<b>Docket Number:</b>	08-AFC-08A
<b>Project Title:</b>	Hydrogen Energy Center Application for Certification Amendment
<b>TN #:</b>	200676
<b>Document Title:</b>	Comments on DEIR and PSA
<b>Description:</b>	general comments
<b>Filer:</b>	Tom Frantz
<b>Organization:</b>	Association of Irrigated Residents
<b>Submitter Role:</b>	Intervenor
<b>Submission Date:</b>	9/30/2013 7:33:56 PM
<b>Docketed Date:</b>	9/30/2013

Comments to the Department of Energy re the Draft Environmental Impact Statement for Hydrogen Energy California via email: [fred.pozzuto@netl.doe.gov](mailto:fred.pozzuto@netl.doe.gov) and also to the California Energy Commission re the Preliminary Staff Assessment, Docket No. 08-AFC-8A submitted electronically

The chart below of PM2.5 Design Values also shows little to no improvement for the Bakersfield-California Ave. monitor since 2005.

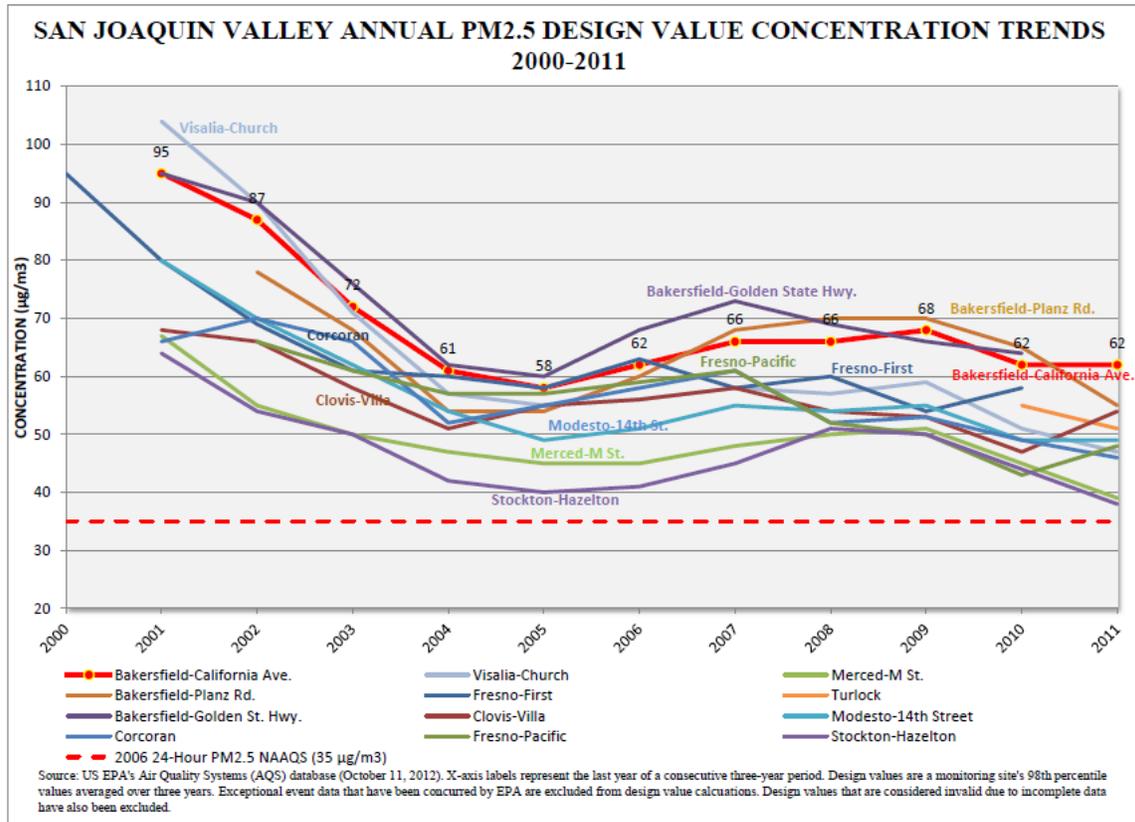
ERC use is therefore not justified for the obvious reason that progress in meeting air quality standards has stagnated in recent years and HECA will introduce significant new emissions into the Kern County air basin. The CEC and the DOE can over-rule the SJVAPCD in deciding whether there is reasonable progress in these areas. Please use some logic and actual data as well as looking at the letter of the law in deciding these issues.

The google earth photo below shows clearly an alternative water source in the evaporation/percolation ponds about 15 miles directly west of the HECA site.

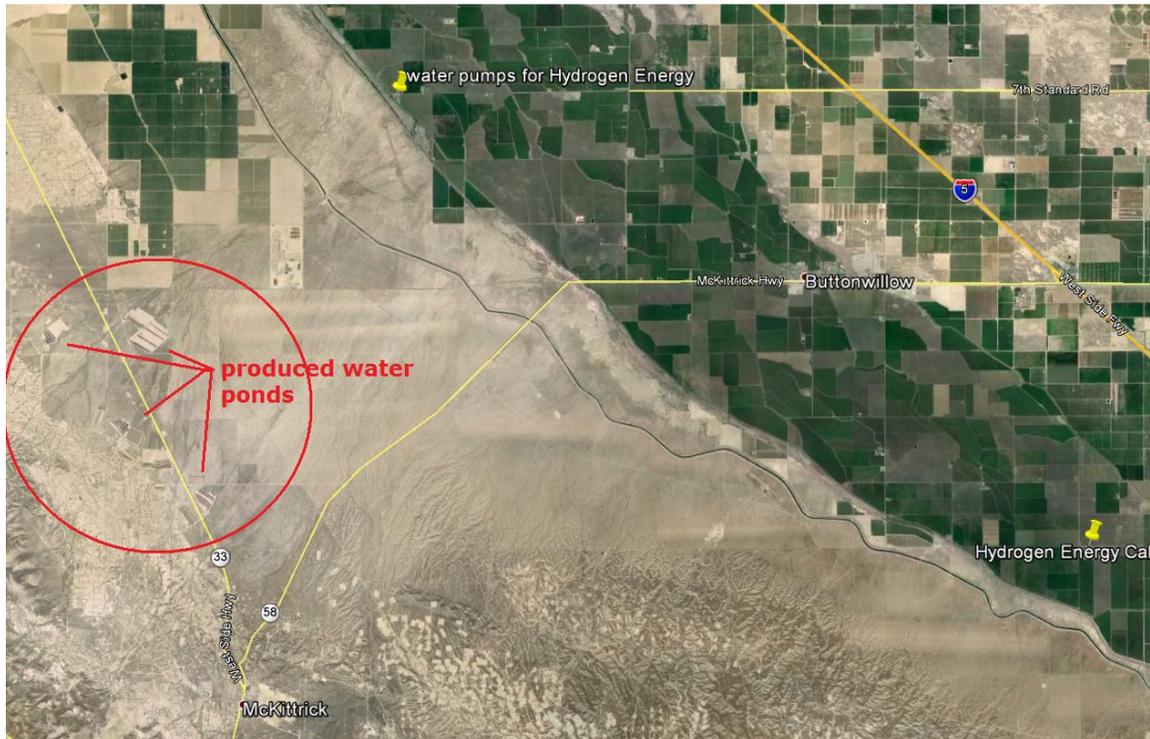
A pipeline could follow Lokern Road and cross the aqueduct above ground and then follow the proposed route for water from the proposed Seventh Standard road and Kern River bed site.

2011 Water Supply Report  
Figure 18, Page 62

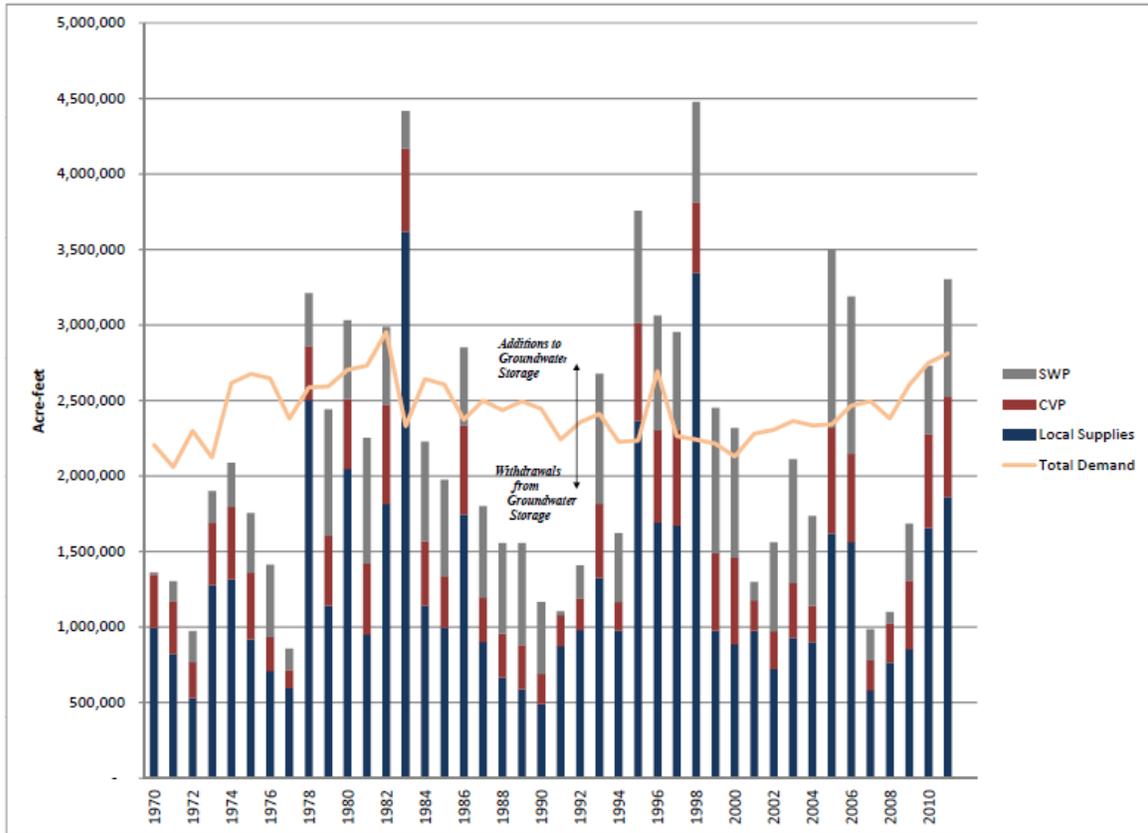
Below is a table of water supply in the Kern groundwater sub-basin from 1970 through 2011 made by the Kern County Water Agency. The analysis of this information shows an annual average groundwater overdraft of approximately 80,000 acre-feet per year over this time period. The cumulative overdraft during this time is 3.4 million acre feet. 2012 and 2013 are significant overdraft years as well.
